Seq X Draft, June 8, 2018_TWB_CLEAN
(based on CW ASTM Draft Rev 4.docx)

Date: June 8, 2018
To: Subcommittee D02.B0 members
Technical Contact: Terry Bates, batesterryw@aol.com
Work Item: WK49675
Ballot Action: New engine oil test method
Rationale: This test method is expected be in a new engine oil specification

Standard Test Method for Determination of Timing Chain Wear in a Turbocharged, Direct Injection, Spark Ignition, Four-Cylinder Engine¹

FIG. 1 Accelerator Position Wiring Schematic

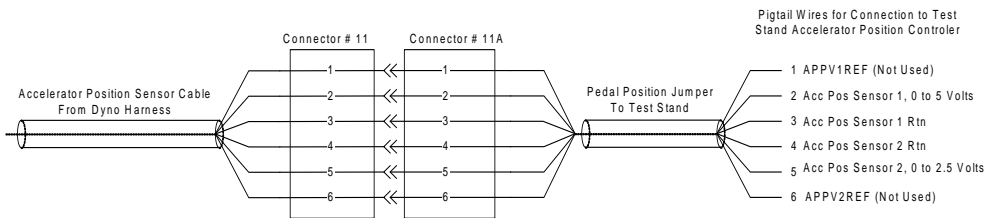
Comment [TB78]: The SI does not allow letters to be attached to SI unit symbols. So 'Vdc' is not allowed.

Comment [TB79]: Having moved Figs 1 to 12 to Annex A9, this is now the first Fig in the body of the method, so is Fig 1.

FIG. 2 Blowby Cart Connection

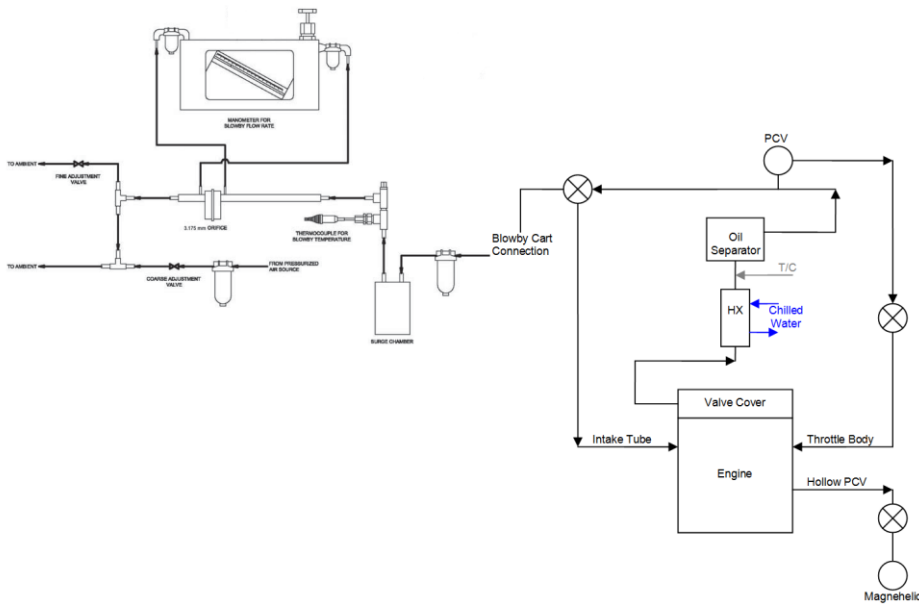
Comment [TB107]: Not sure what Fig is intended here. There are two Figs. 9 in the original draft, one of the fuel system and one (in section 9.3.1) of the Blowby Cart Connection. On the assumption that the Blowby Cart connection Fig is intended, I have moved it from section 9.3.1 to here and called it Fig. 2. Please confirm this is the Fig involved in 8.26.1.

Comment [TB110]: Figs 2 to 12 of the original draft have been moved to Annex A9 so this is now Fig. 2.

Fig. A7.1: Piston Ring Setter

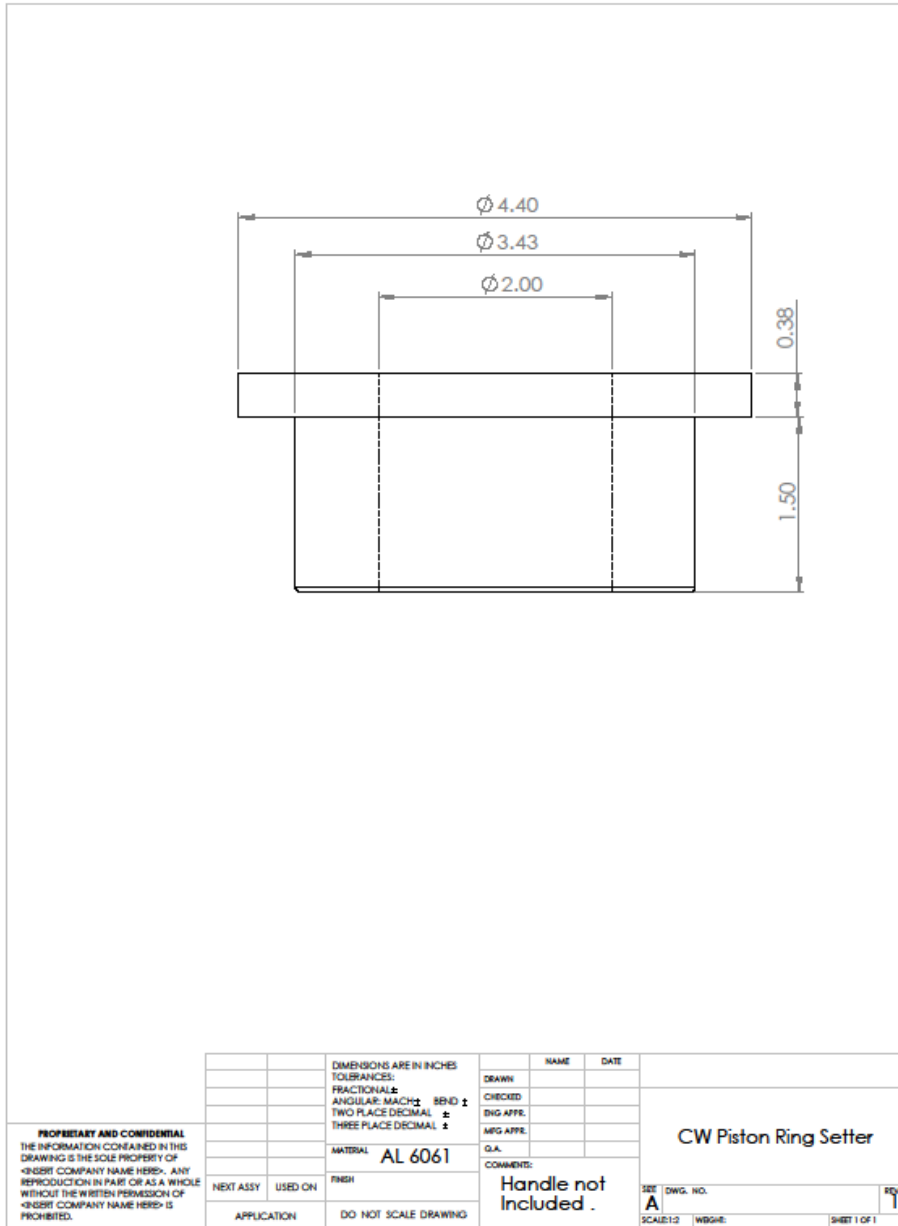
Comment [TB173]: Can we have dimensions in mm, as with Fig A7.2 as 1.2 says SI units are the standard.

FIG. A9.1 PCV Valve Flow Test Apparatus

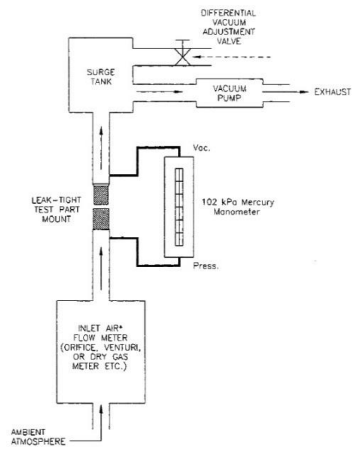
Comment [TB28]: This info was in a Note in Fig 1. But ASTM does not allow mandatory info to be in a Note so have moved the info to 8.3.2.2.

Comment [TB174]: Mandatory info cannot be in a Note so have moved this info to 8.3.2.2.

Comment [TB175]: This was originally Fig 1.

FIG. A9.2 Water-Pump Drive Arrangement

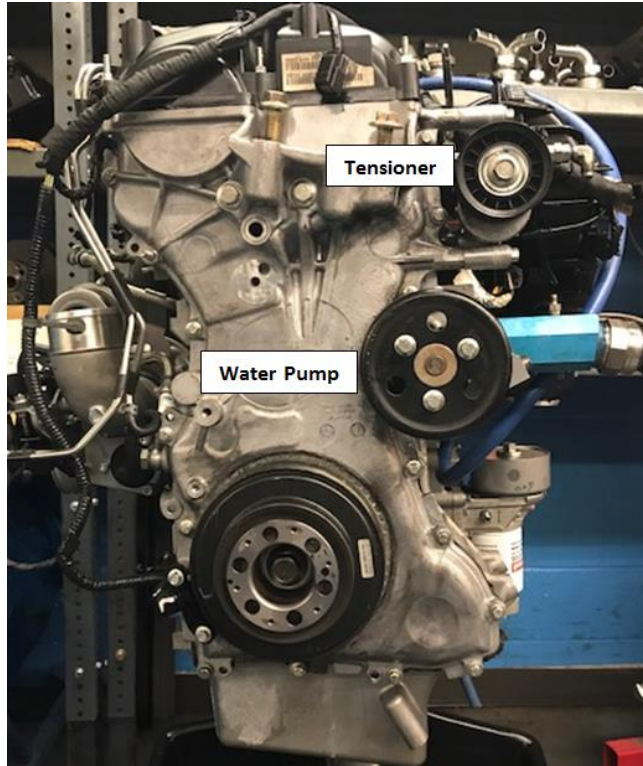
Comment [TB42]: Fig 7 Water Pump Drive Arrangement has been deleted. Please confirm there is no longer any such Fig.

Comment [TB176]: This was originally Fig. 2

FIG. A9.6 Oil Pan

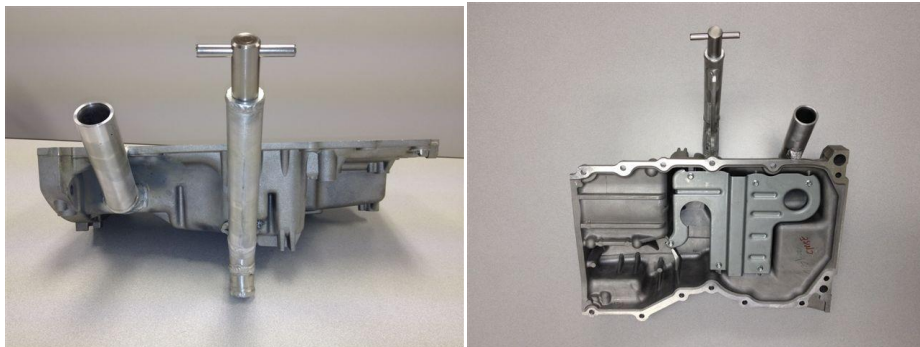
Comment [TB6]: There is no mention of a fill port in Table A5.7 or anywhere else in the method.

Comment [TB7]: Fig 6 has been moved to Annex A9 and is now Fig A9.6

Comment [TB180]: This was originally Fig 6.

FIG. A9.7 Oil-Gallery-Temperature Control System

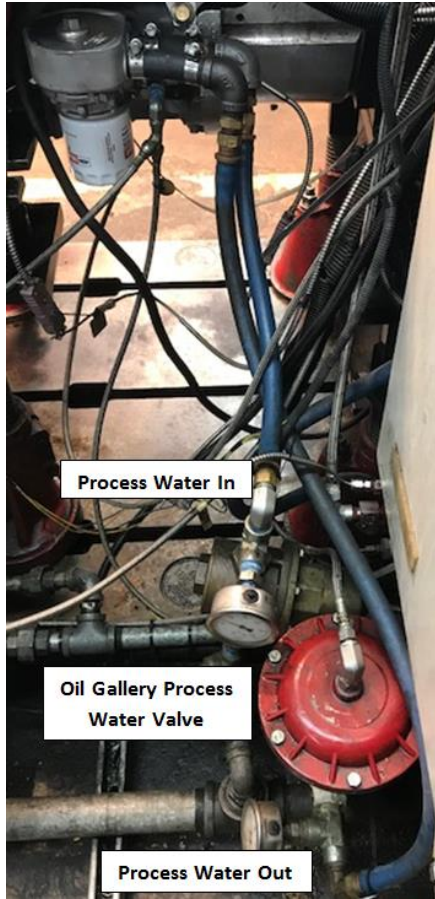
Comment [TB45]: The original draft did not refer to Fig X anywhere. I have done so here. Is that correct?
Note: Fig X has been moved to Annex A9 and is now Fig A9.7.

Comment [TB181]: This was originally Fig X.

FIG. A9.13: Intercooler Tubing Measurements and Instrumentation

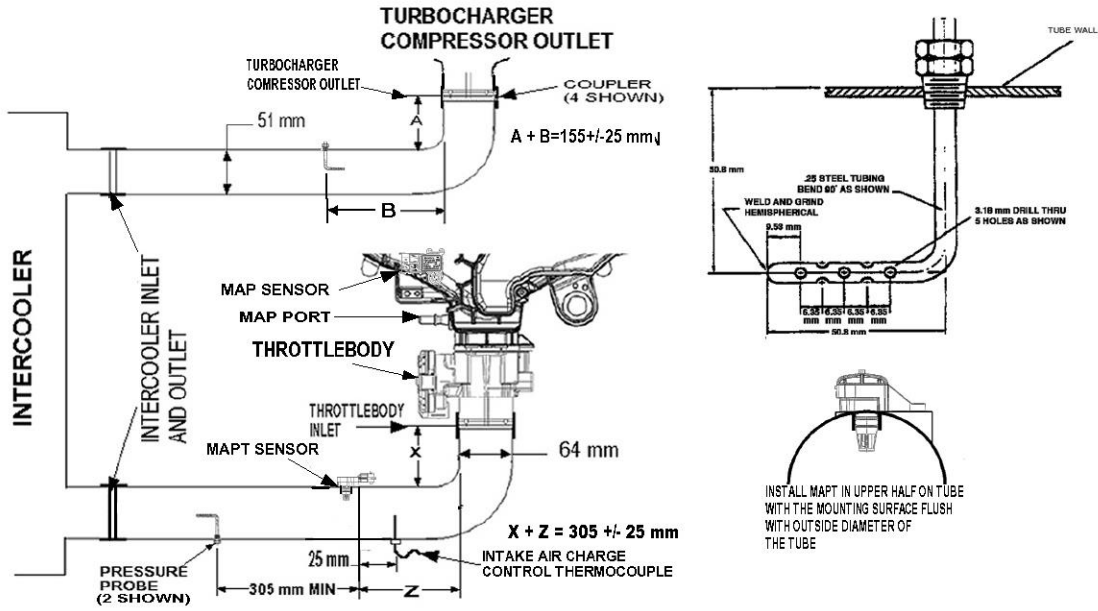
Comment [TB74]: Why are we giving inch equivalent here and not elsewhere in 8.21.14. Also no inch equivalents given in Fig A9.13. Can we delete the inch equivalents in (d) and (e)?

Figure A9.14 Typical intercooler installation

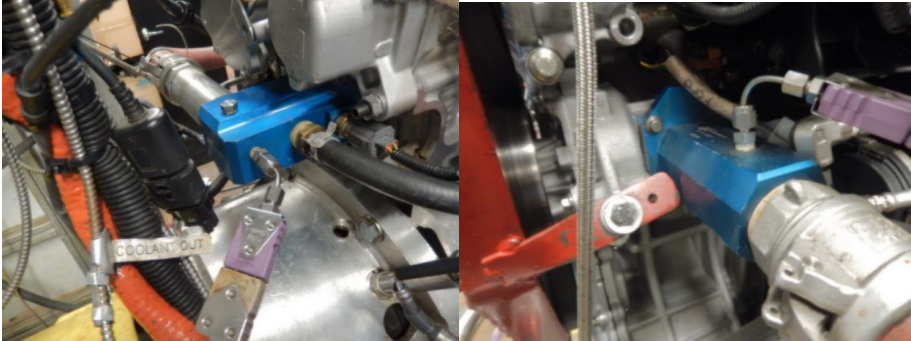
Comment [TB187]: This is now Fig A9.12. It was originally Fig 12.

FIG. A9.14 Coolant in and out connections and thermocouple locations

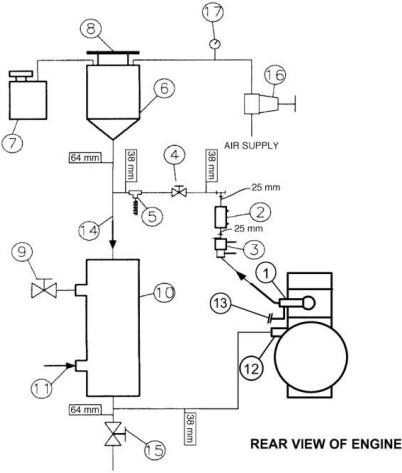
Comment [TB188]: It is not normal to include numbered Notes in Figs. Also Notes shall not include mandatory requirements and usually offer informative suggestions. So have deleted Note 1 and 2 from Fig

FIG. A9.24 Oil Out Temperature Location In Oil Filter Adapter (Dimensions In mm)

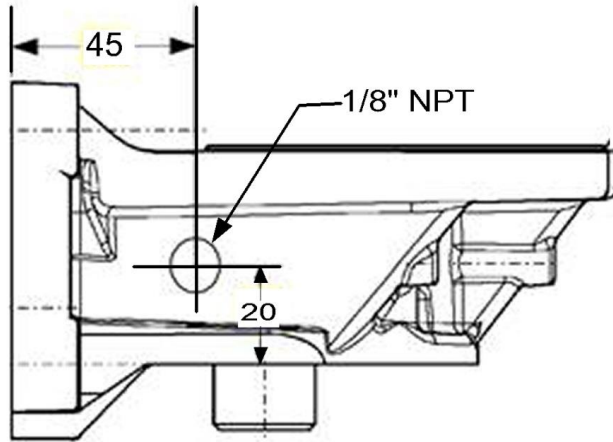
Comment [TB89]: Fig A9.3 was specified in the original draft. But the only Fig showing a 1/8" NPT is Fig A2.16 which presumably should be called Fig A9.16 and which is now Fig. A9.24. Is Fig A9.24 the correct Fig.?

Comment [TB189]: Is this the correct title for this fig?

Fig. X2.1 Right Engine Bracket

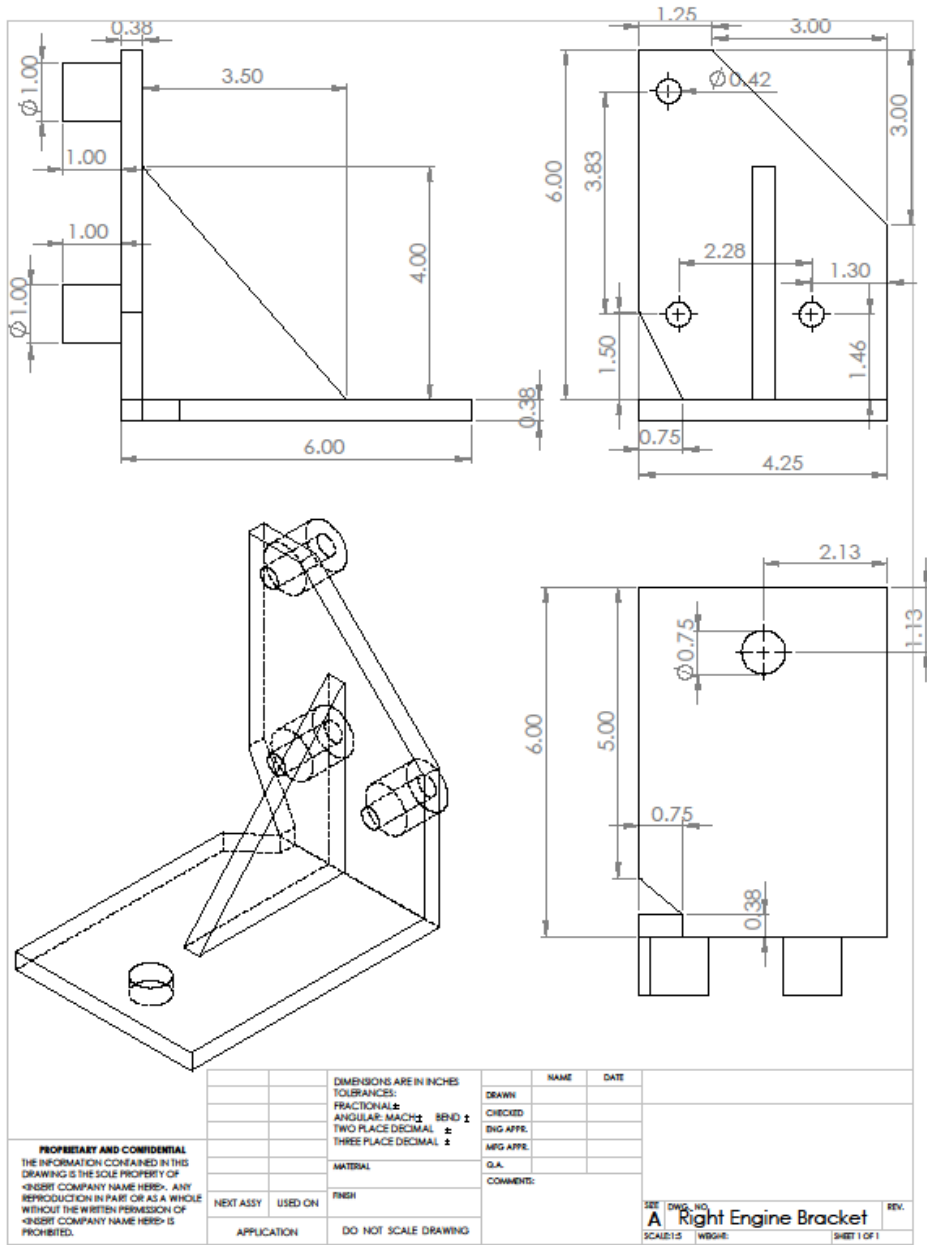
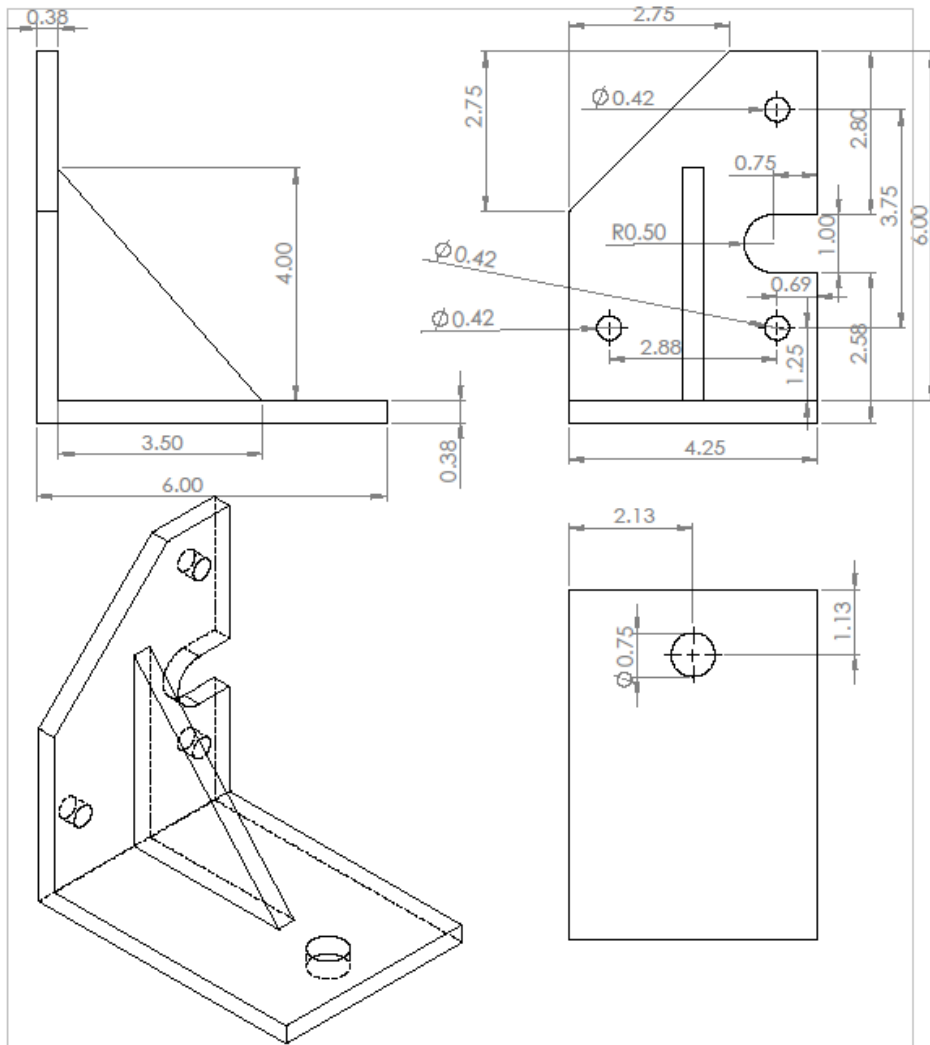
Comment [TB57]: Information in an Appendix is not mandatory and cannot be part of the test method. Why are the bracket dimensions given in an Appendix and not in an Annex which is a mandatory part of the test method?

Comment [TB193]: Is this verbiage correct?
